Technical Advisory Committee

Monday, May 6, 2024
1:30 PM

City of Hollywood

C. **Preliminary Site Plan Review**

A-3

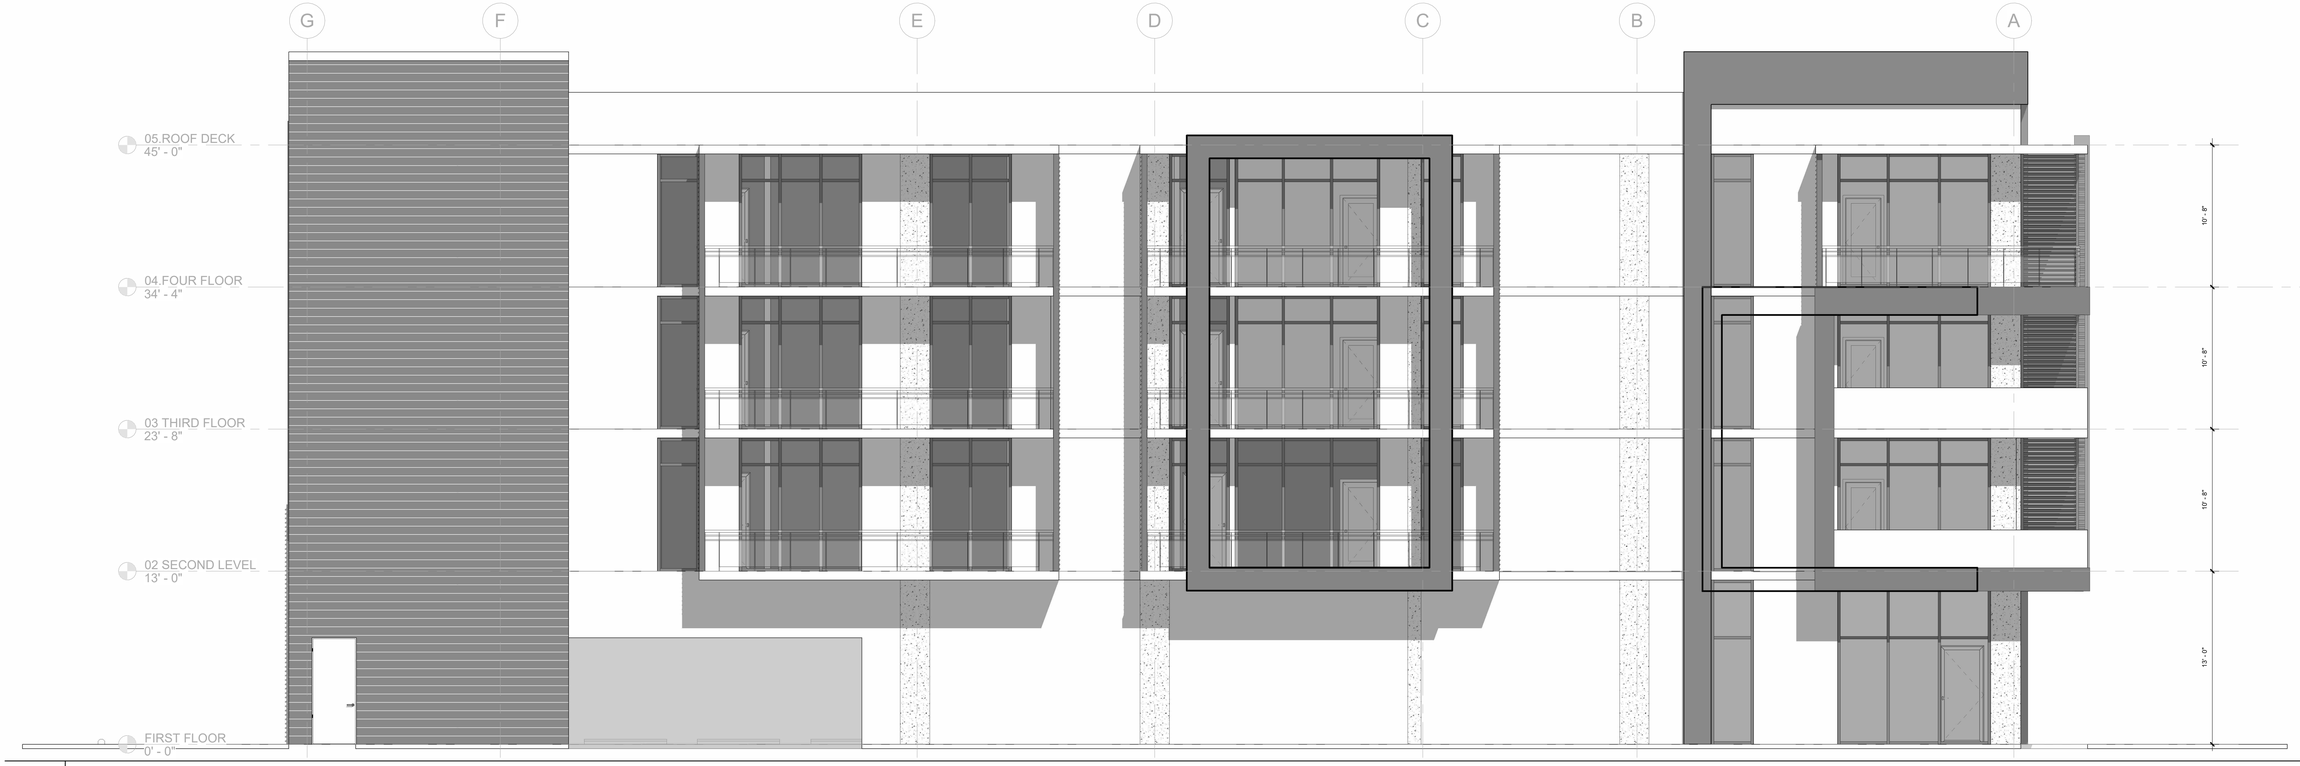
j. Make door entry way for commercial unit #1 consistent with commercial unit #4. Show consistency on elevations sheet.
Response: unit#1's door has match with the unit#4's door. Please see the revised floor plan A-1 and elevation on the sheet A-3.

k. Label proposed elevations correctly. "Proposed Front (South)" should be "Rear."
Response: Elevations label is corrected. Please see the revised sheet A-3.

9. Sheet SP-1 indicates FFE = 12.00' NAVD88 and Sheet A-3 indicates the finished floor at 11.25' NGVD29. Ensure all elevations reference NAVD88.
   Response: Proposed building's finished floor elevation is 12.0' NAVD. Please see the revised elevation on the sheet A-3.

DATE: 09/10/2022
DRAWN BY DM
PROJECT NO. 2022–00129
REVISED BY MN
SHEET NO. **SP-1**

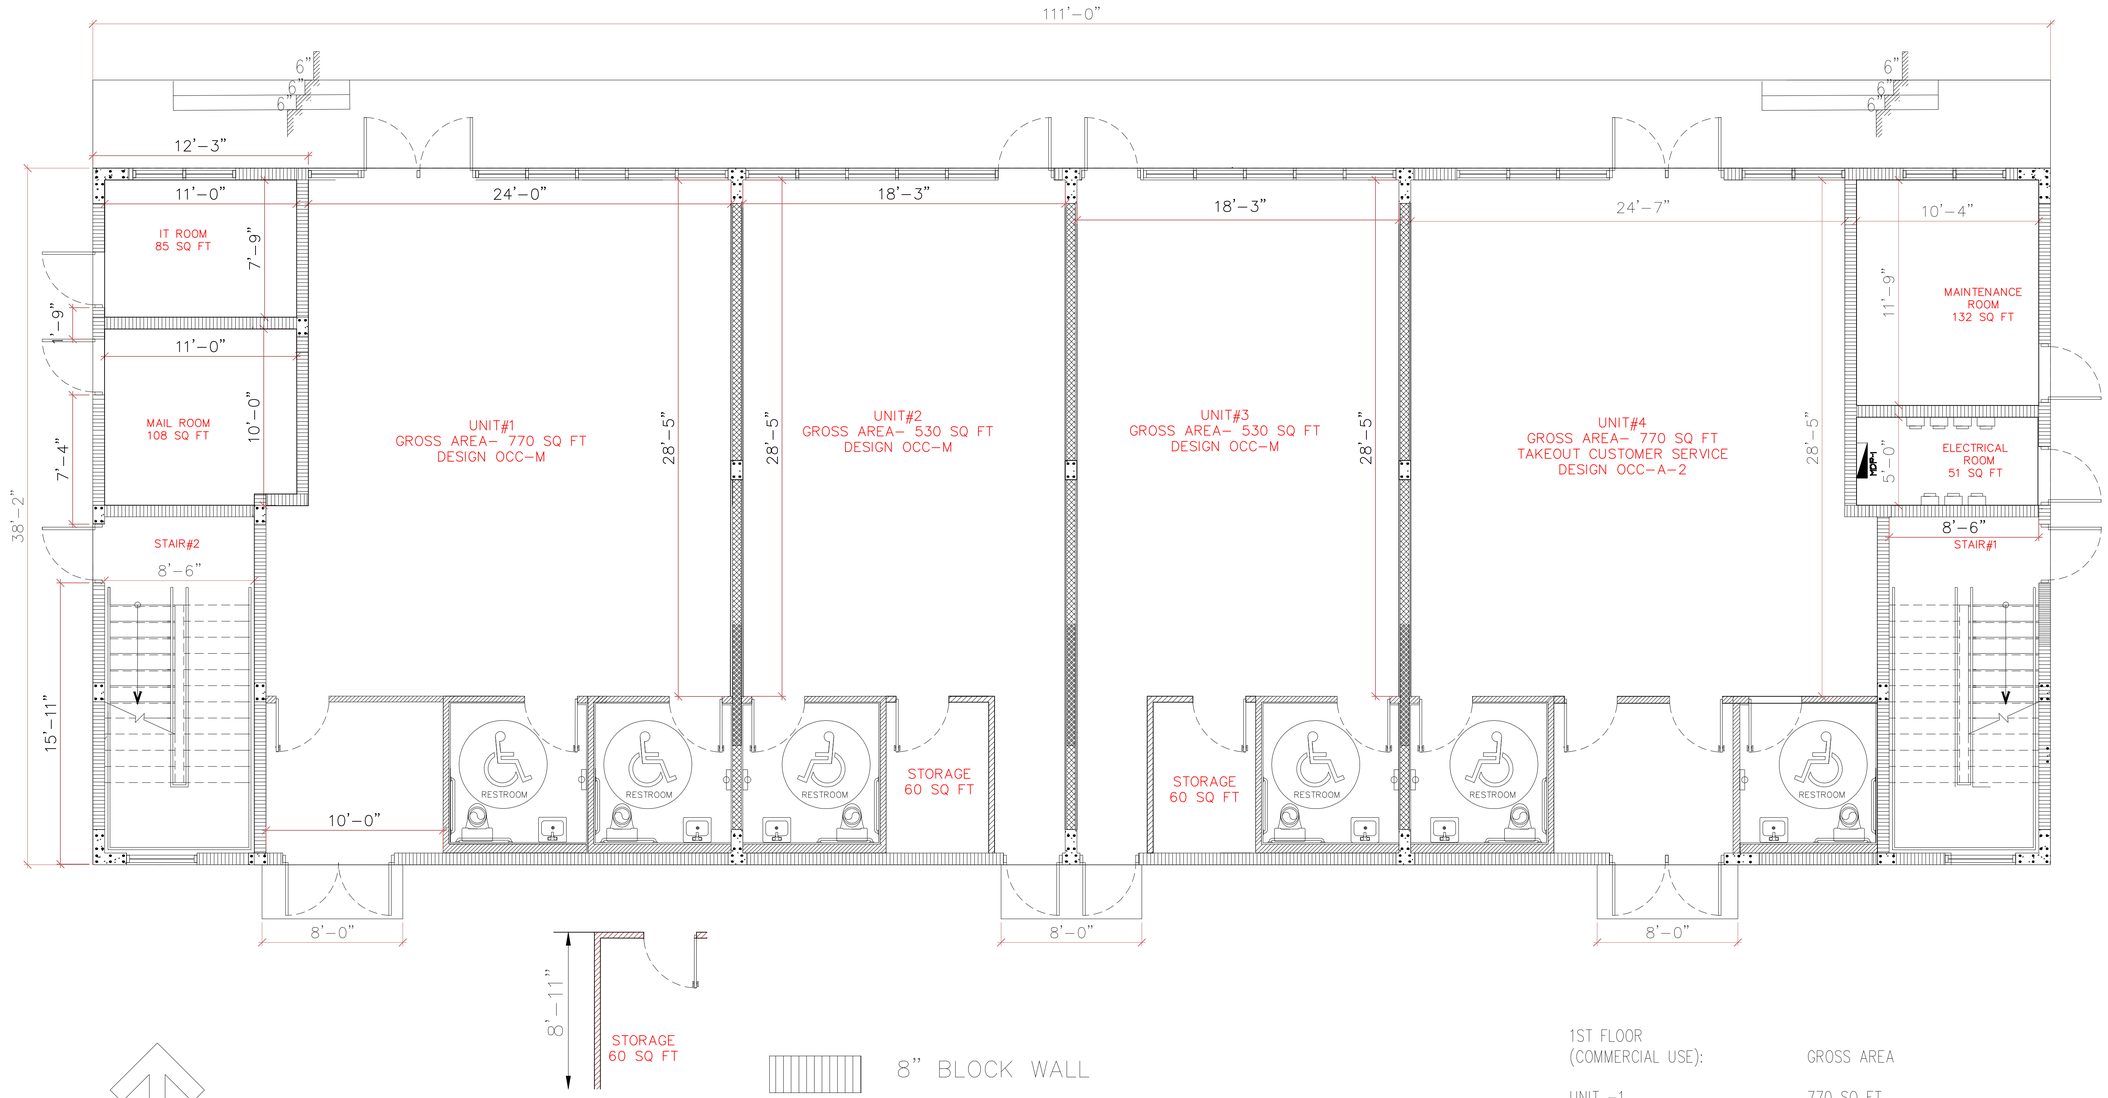
m. Provide VUA calculation on site plan. Shall not include the required 5' landscape buffer.
Response: VUA calculation is shown on the revised site plan. Please see the sheet SP-1.

8. Please clearly identify material for the parking lot, the driveway and the driveway apron. Sheet SP-1 is calling out parking lot as driveway.

10. On Sheet SP-1, Applicant shows two (1'-3" and 1'-1" wide) strips parallel to the entrance/exit driveway. Please clarify what these are, identify material and if they are raised and above ground features. Provide height and any applicable details as needed.
    Response: Both of the 6" raised traffic separator concrete curb to be 1'-3" in wide and 6" above the ground. The curb details will be provide on the civil plan during construction permit.

15. Parking lot setback shall be measured from outside of curb to the property lines. A separate dimension shall be provided for the curb width.
    Response: Response: Please see the revised site plan and new dimension on the revised sheet SP-1.

8. Indicate FFE for all enclosed areas on the ground floor.
   Response: Proposed building's finished floor elevation is 12.0' NAVD. Please see the information on the sheet SP-1 and C-1.

8. Provide a note on civil drawing all underground fire main work must be completed by fire protection contractor holding a Class I, II, or V license per FS 633.102.
   Response: a note is added on the sheet SP-1.

Sheet No.
C-9.0

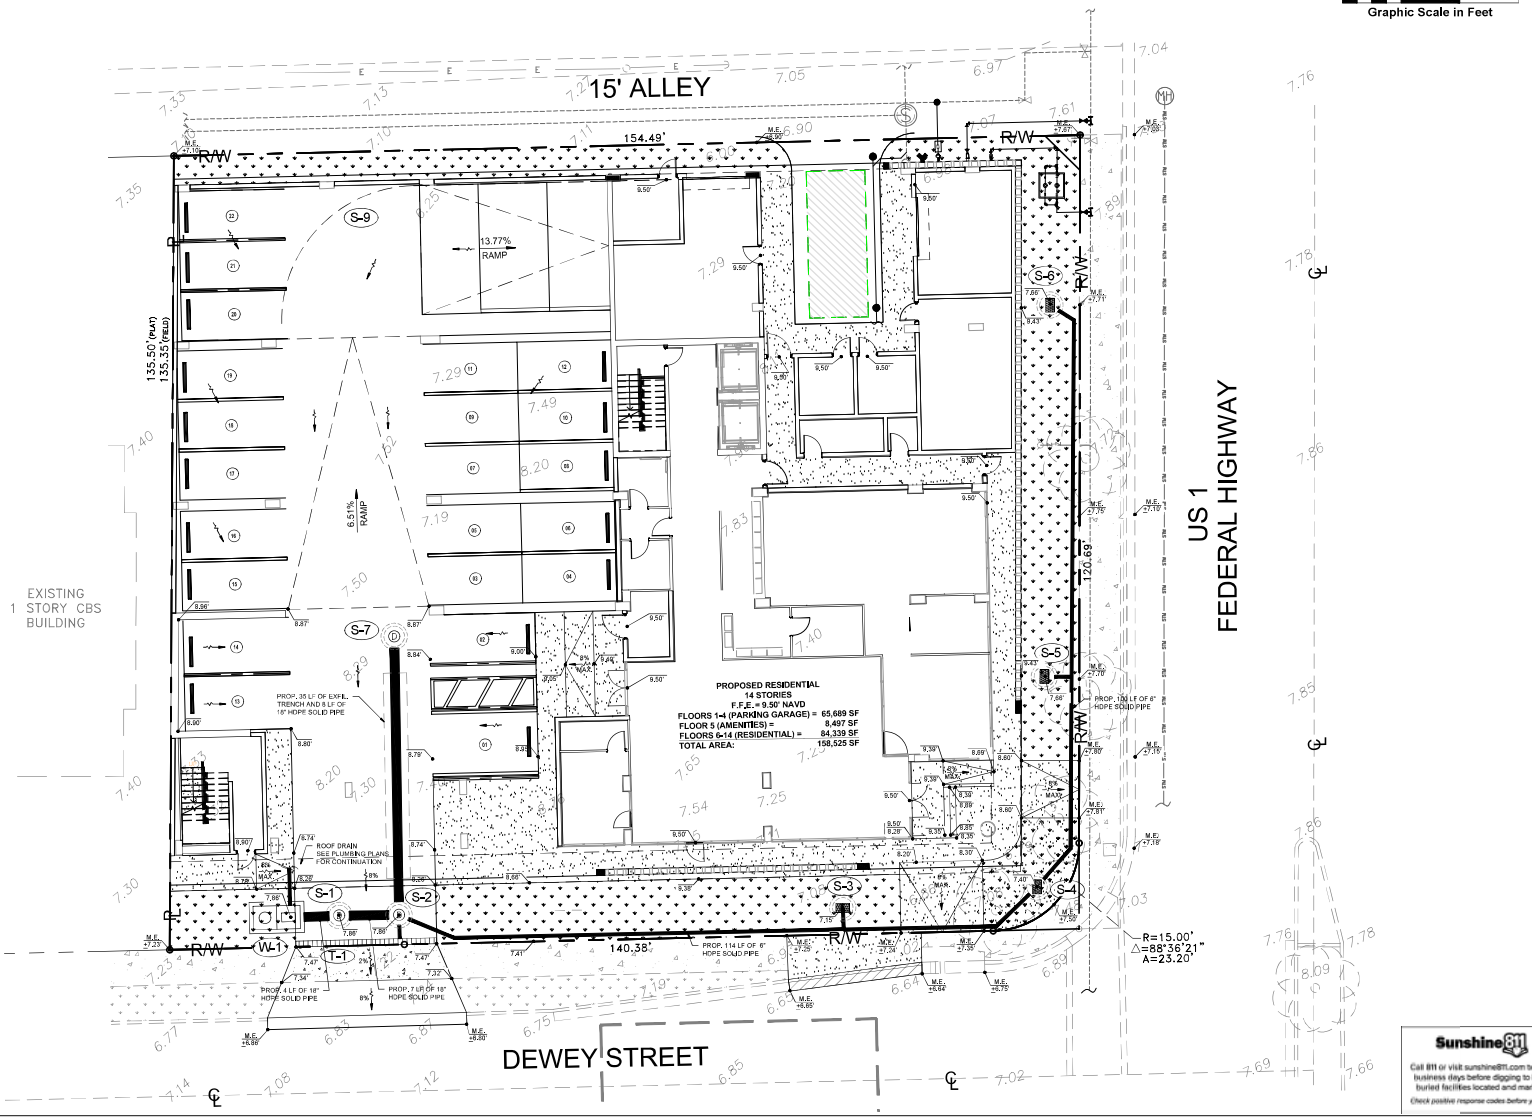
23. Per Paving and Drainage Plan, Sheet C-9.0, the proposed private drainage system inlets / low points are at the property line; please shift further into private property.

Response:
Agree, structure has been moved. See Sheet C-9.0 Grading and Drainage Plan

Sheet No.
C-4.0

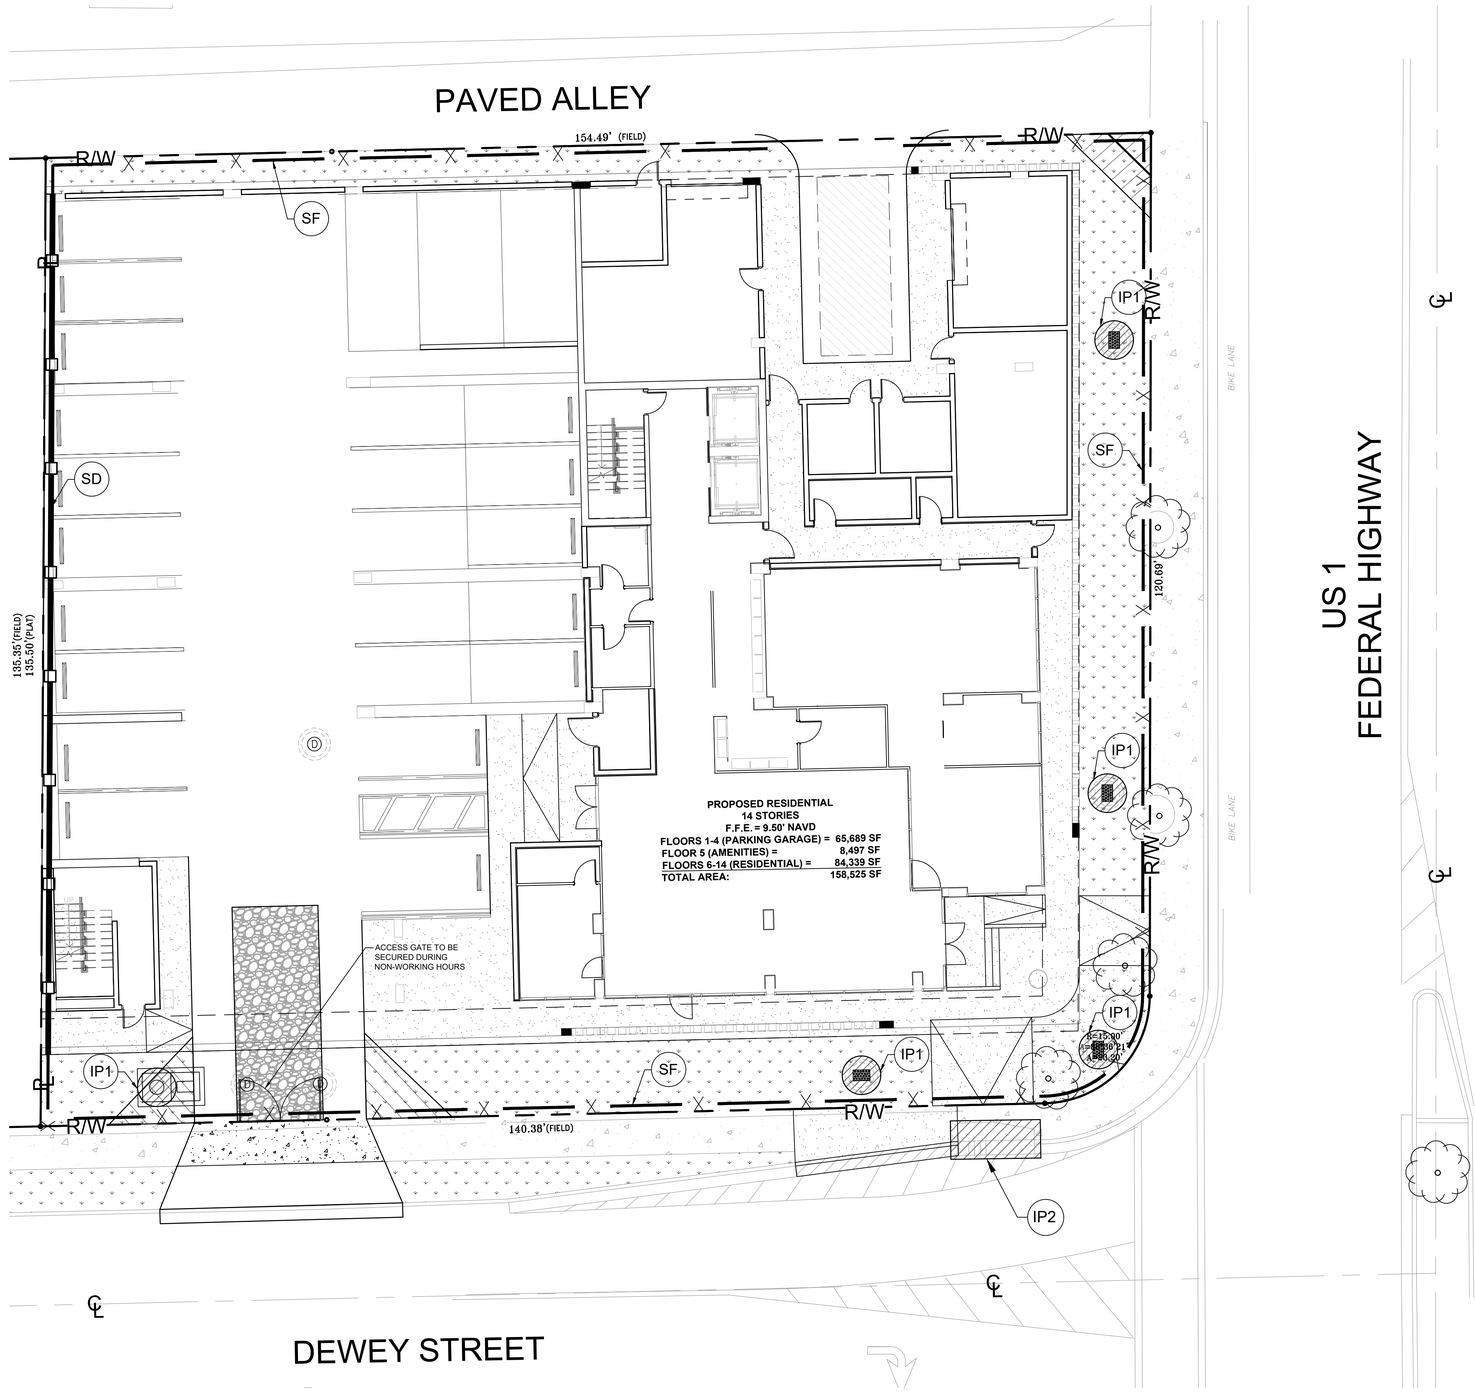
Response:
It has been added as per the review comment. Refer to Civil Drawings
See Sheet C-4.0 Erosion Control Plan and C-4.1 Erosion Control Details

Sheet No.
C-5.0

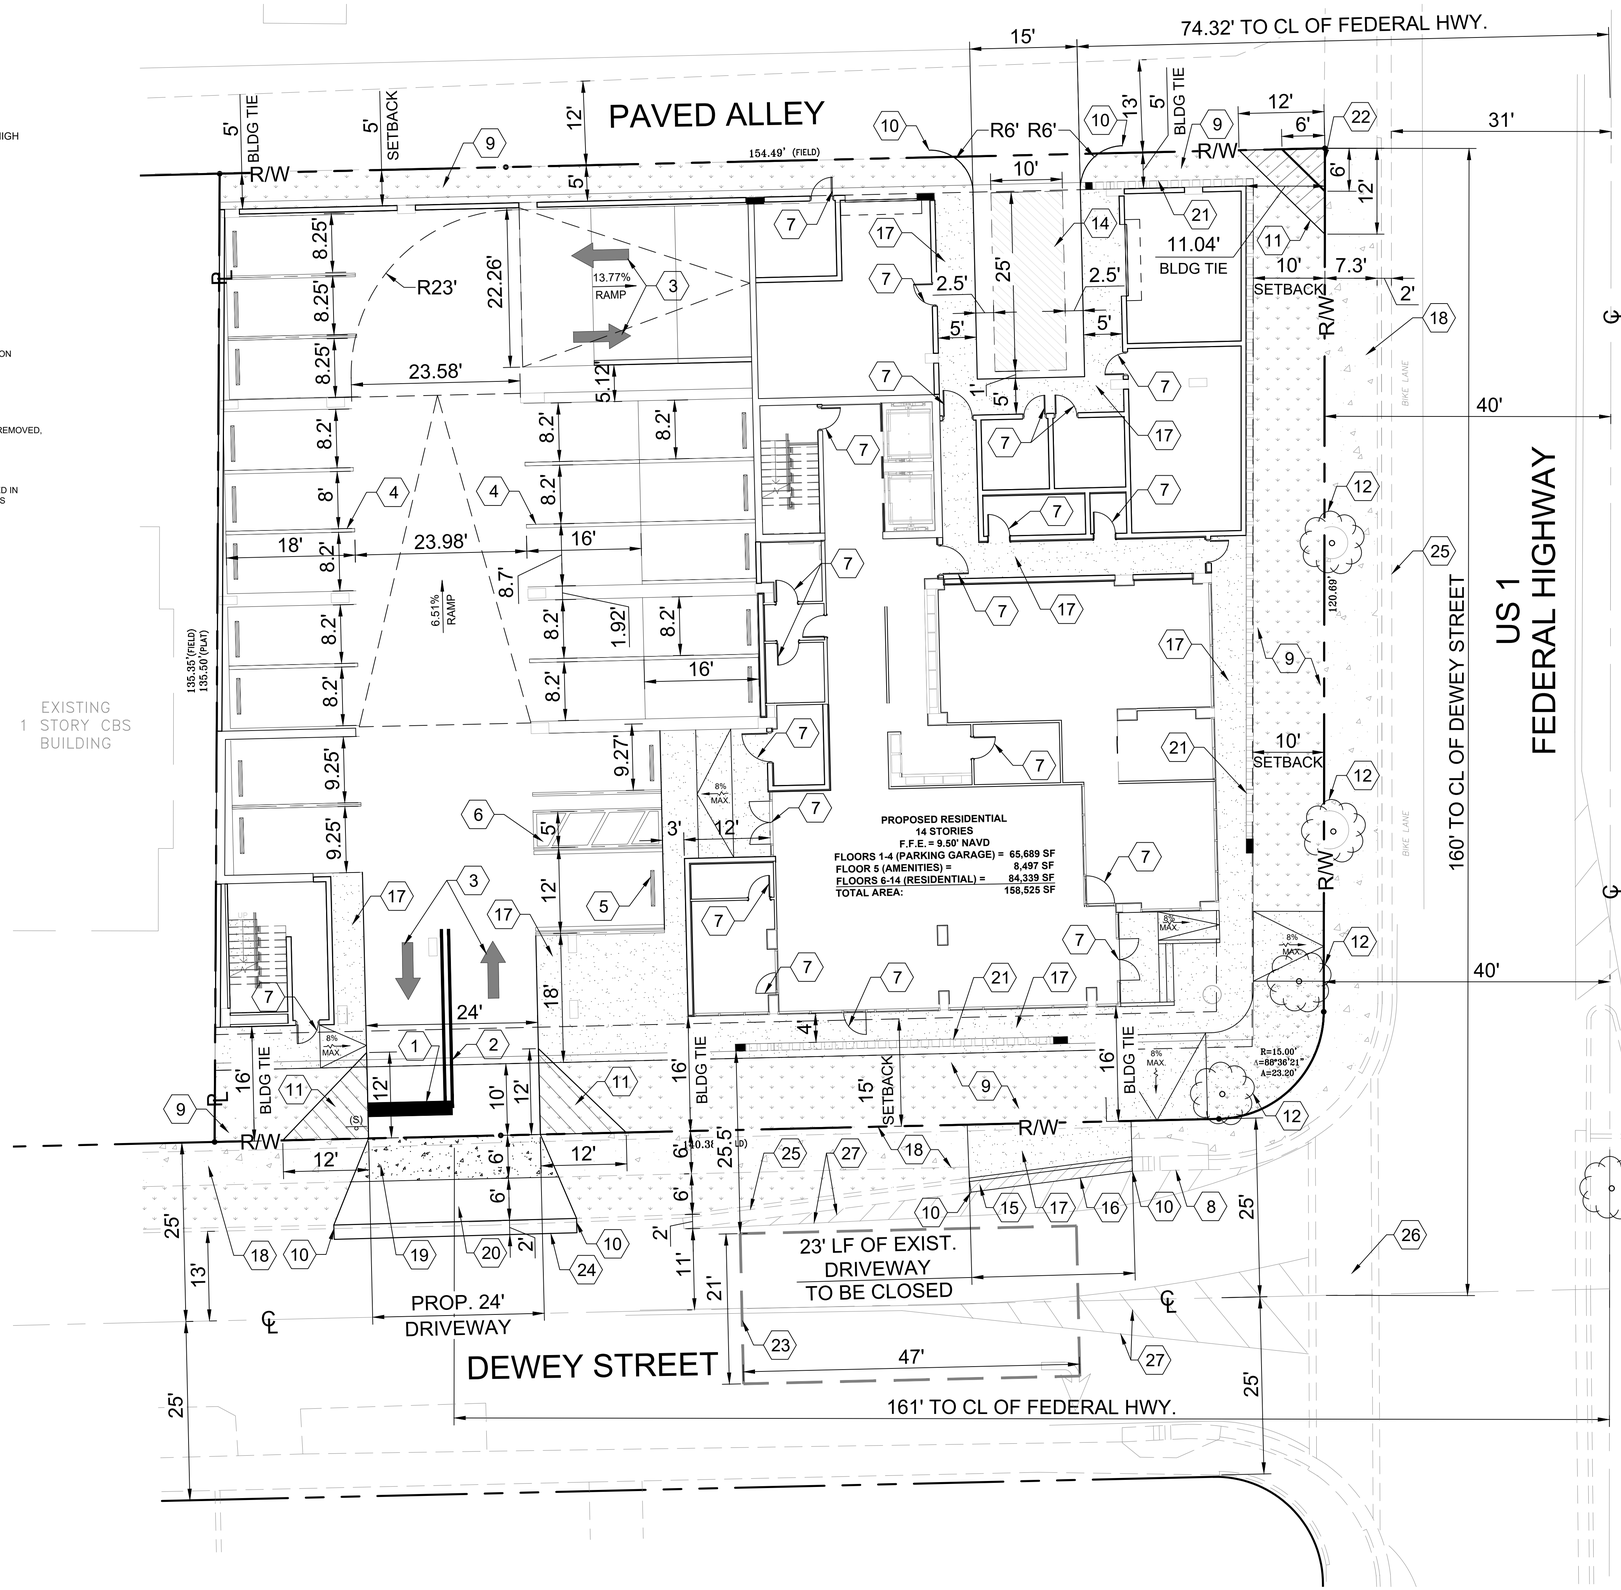
Response:
   Acknowledged. The 15ft setback dimension has been added. See Sheet C-5.0 Site Plan

Response:
Acknowledged. Note has been added. Please refer to sheet C-5.0 Site Plan.

Response:
   Triangle has been added. Please refer to sheet C-5.0 Site Plan.

Response:
A visibility triangle has been provided. See Sheet C-5.0 Site Plan.
